PARTS & SERVICE NEWS

REF NO.	AA03009
DATE	January 14, 2003

SUBJECT: LEAKAGE FROM TRANSMISSION REAR COUPLING, SLIDING TYPE

PURPOSE: Introduce a repair procedure for transmission rear coupling leakage.

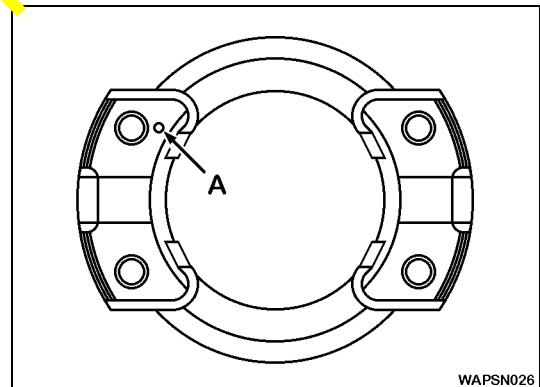
There is a possibility of oil leaking between the coupling and the inside cover. It has been improved by changing the clearance tolerance from a loose fit ① to a tight fit ②. Sealant ③ is now applied on each side of the inside cover. In order to clarify the improved coupling, an identifying mark **A** is punched as shown. Make sure it is indicated on the new part before replacement.

New Part	Description	Old Part
714-13-14121	Rear Coupling	714-13-14120

1. Replace the coupling according to the instruction in the shop manual.
